HISTORIC AND DESIGN REVIEW COMMISSION

HDRC CASE NO: 2020-001
ADDRESS: 819 LAMAR ST
LEGAL DESCRIPTION: NCB 1368 BLK 5 LOT 19
ZONING: R-6, H
CITY COUNCIL DIST.: 2
DISTRICT: Dignowity Hill Historic District
APPLICANT: Michael Cisneros/Harmony Custom Homes
OWNER: Nickolas Markov
TYPE OF WORK: Construction of a 1-story residential structure
APPLICATION RECEIVED: August 21, 2020
60-DAY REVIEW: Not applicable due to City Council Emergency Orders
CASE MANAGER: Edward Hall

Historic and Design Review Commission
Design Review Committee Report

RIGHT ELEVATION

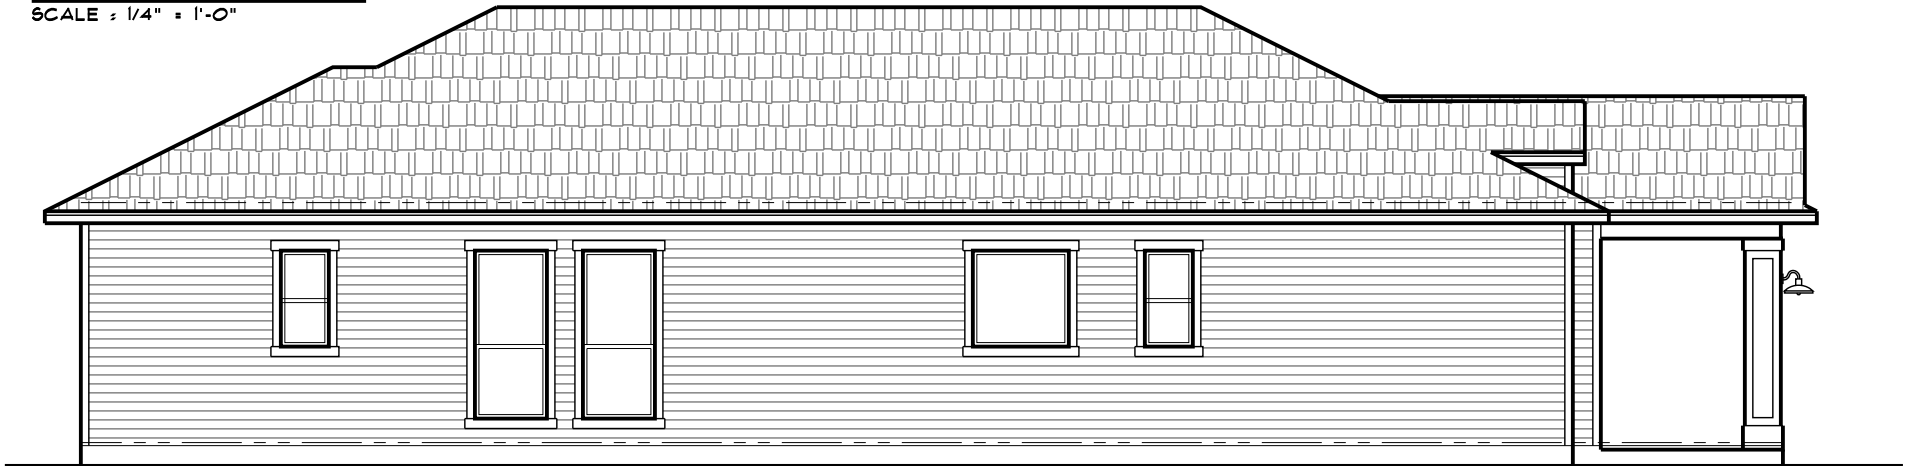
- l. **WINDOW & DOOR OPENINGS** – Per the submitted documents, the applicant has proposed blank walls near the front elevation on both side elevations. Staff finds that windows should be added to separate expanses of wall that do not feature windows. Additionally, window should be grouped in a manner that is consistent with those found historically on the block, be separated by a six inch wood mullion rather than siding, feature a one over one profile and equally sized sashes.

JF: Windows should be added to both side facades.

- v. That fenestration be added to blank walls on the east and west elevations, and that window be grouped and detailed consistent with those found historically on the block. Windows should be separated by a wood mullion of six inches in width, and should feature sizes and profiles that are consistent with those found historically within the block and district.

REAR ELEVATION

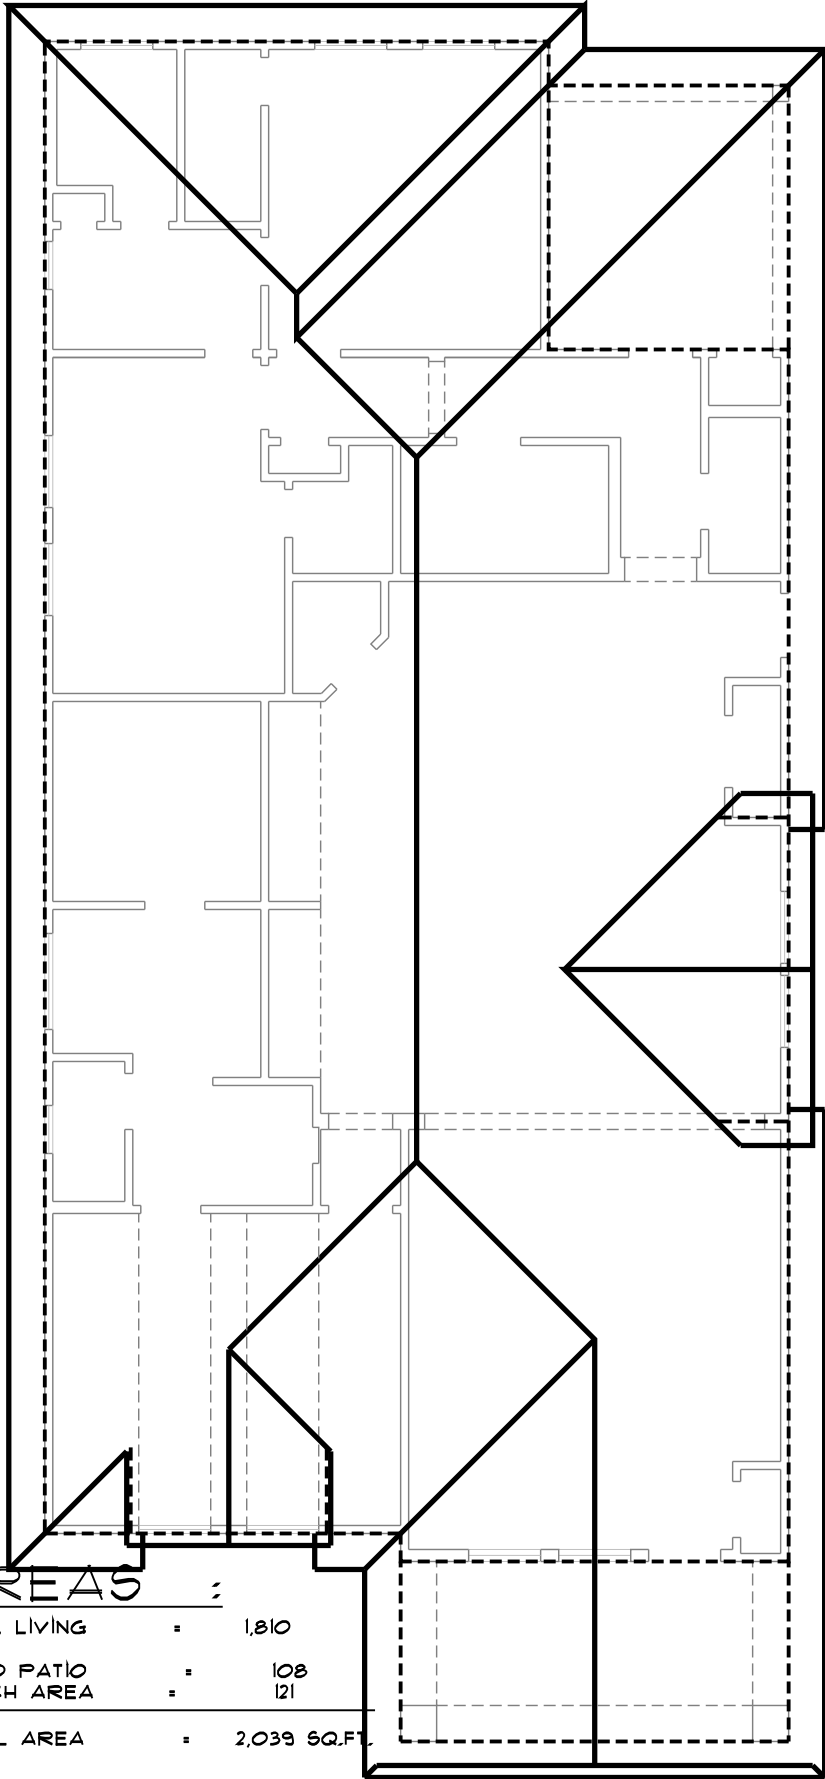
- g. **FOUNDATION & FLOOR HEIGHTS** – According to the Guidelines for New Construction 2.A.iii., foundation and floor heights should be aligned within one (1) foot of neighboring structure’s foundation and floor heights. This block of Lamar features historic structures that feature foundation heights of between one and three feet in height. The applicant has proposed a foundation height of approximately one (1) foot in height. Generally, staff finds the proposed foundation height to be appropriate; however, staff finds that the proposed foundation height should be annotated on each elevation.
